RE: Notification of Design Modification to Operable Units 16 (OU16) Site Improvements Project-
Former Diamond Shamrock Painesville Works Site; TER016.600.0002.

**LAKEVIEW BLUFFS
OPERABLE UNIT 16
GRADING AND DRAINAGE PLAN
PAINESVILLE TOWNSHIP, LAKE COUNTY, OHIO**

DESIGN MODIFICATION TO OPERABLE UNITS 16 (OU16)
SITE GRADING AND LANDFILL CAP IMPROVEMENTS PROJECT

**FIGURE 1
STORM SEWER PLAN**

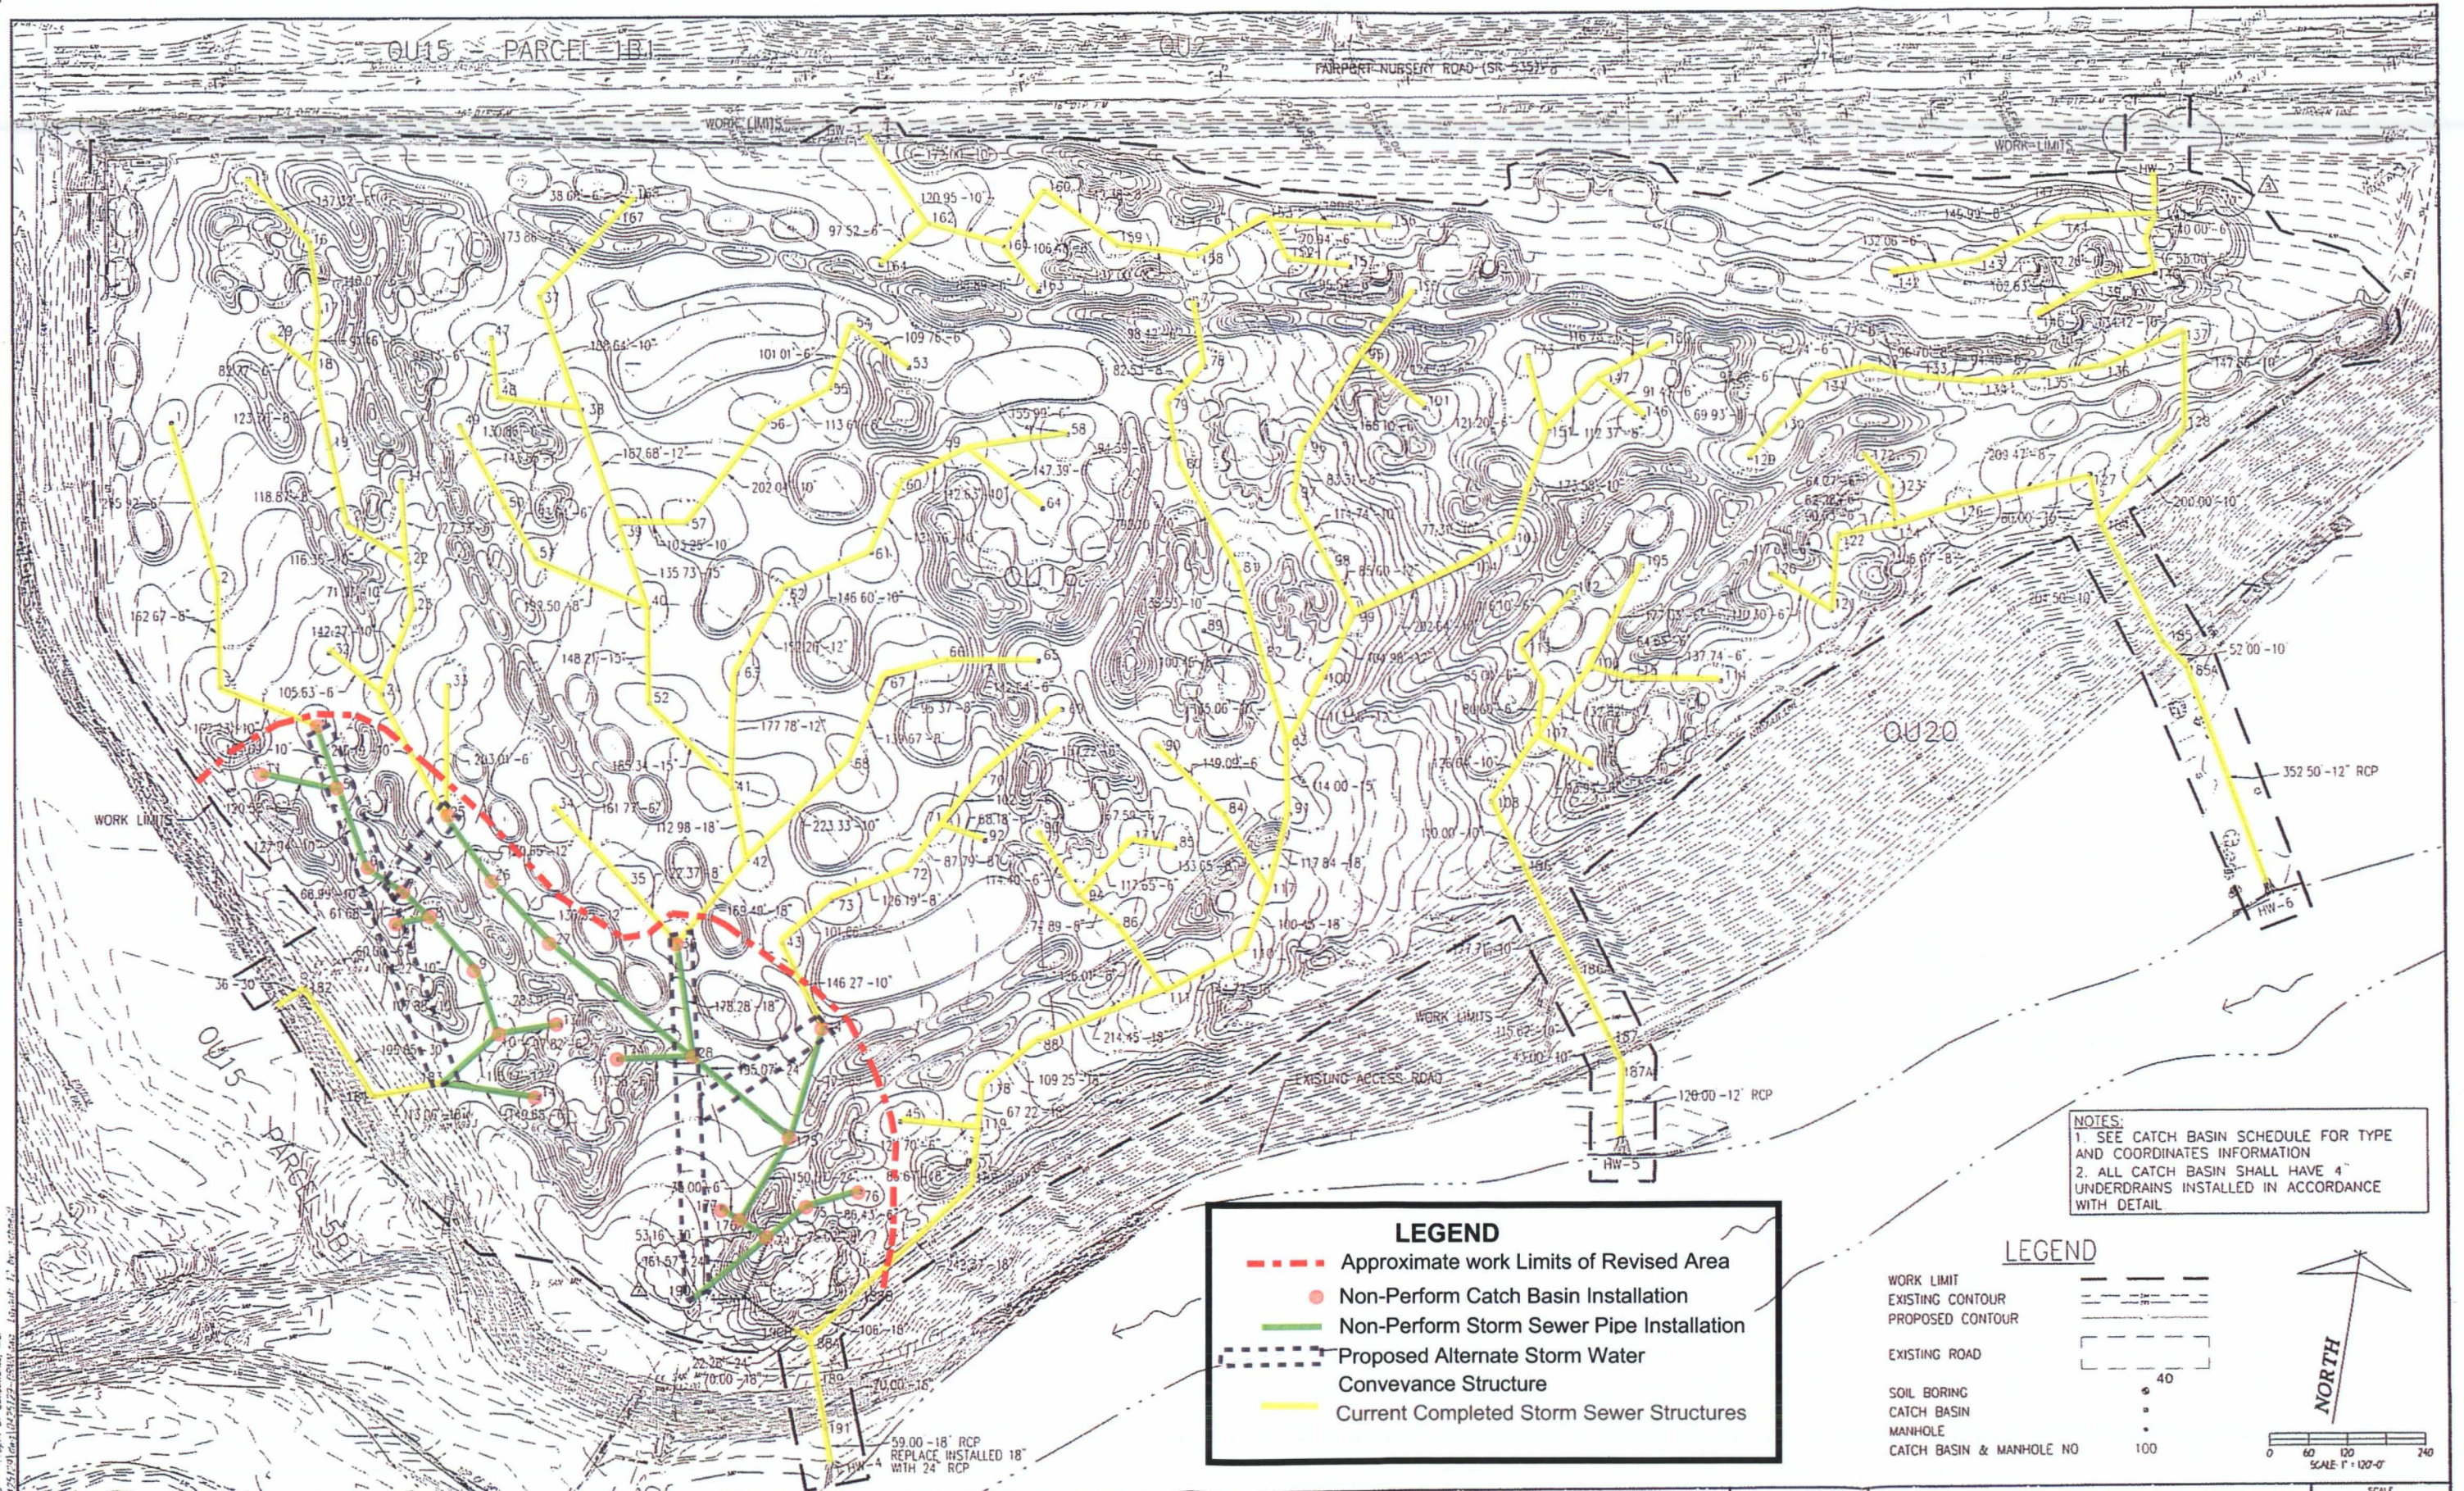
The PRP Group recently reviewed the grading and storm sewer installation design within an approximately 16-acre area located in the southwestern portion of OU16 prior to the completion of these designed improvements. The PRP Group proposes to modify the project design within this area in order to reduce the magnitude of additional fill quantities that otherwise would be required to finish this portion of the work pursuant to the original design. These proposed modifications are consistent with the objectives of the approved IAWP, and the area where changes are proposed is shown on Figure 1.

The modifications proposed in the attached revised grading and drainage plan will result in less storm sewer being installed. Approximately 2,940 feet of storm sewer pipe and as many as 23 catch basin structures will not be installed within the area shown on Figure 1. Storm water conveyance swales will be installed to appropriately manage the storm water in lieu of the planned storm sewers. An engineering analysis was performed and predicted storm water flows and velocities resulting from the upstream storm sewer flows were used to establish the appropriate size and erosion protection in the swales. As a result, the proposed storm water conveyance swales will provide equal performance for storm water flow as the uninstalled storm sewer. Implementing these revised project requirements also will result in approximately 47,000 fewer cubic yards of clean soil fill.

FIGURE 2
OU16 GRADING AND DRAINAGE
DESIGN MODIFICATIONS
FORMER DIAMOND SHAMROCK PAINESVILLE WORKS SITE
PAINESVILLE, LAKE COUNTY, OHIO

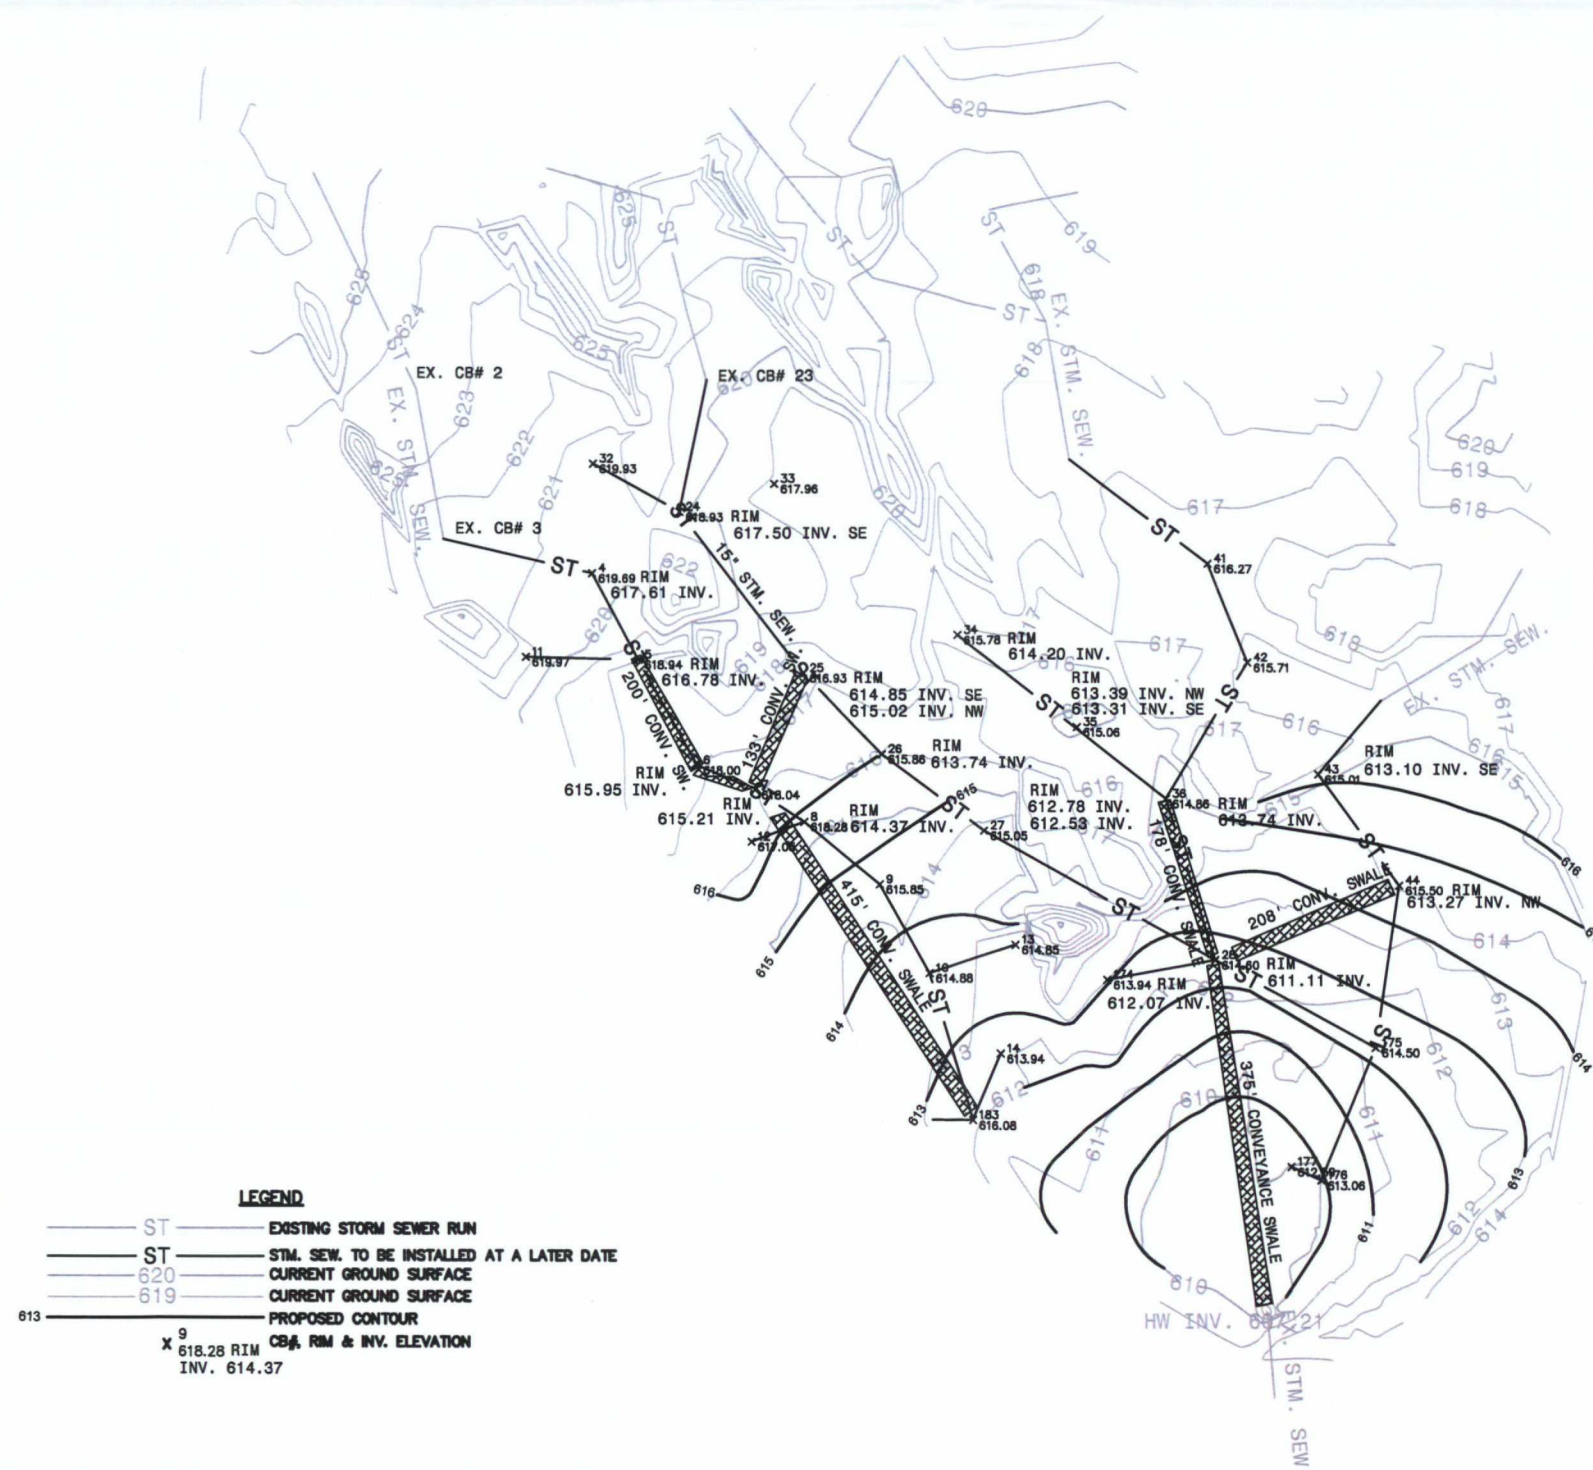
A revised grading and drainage plan was developed based on those criteria. Figure 2 shows the proposed modifications. A comparison of Figure 1 and Figure 2 shows that less soil will be embanked based on the proposed modifications. The revised grading and drainage design also requires some storm sewer pipes originally intended to be covered by the additional golf course fill material to be replaced with storm water conveyance swales in the proposed design. Additional details of the storm water conveyance swales are shown in Figure 3.
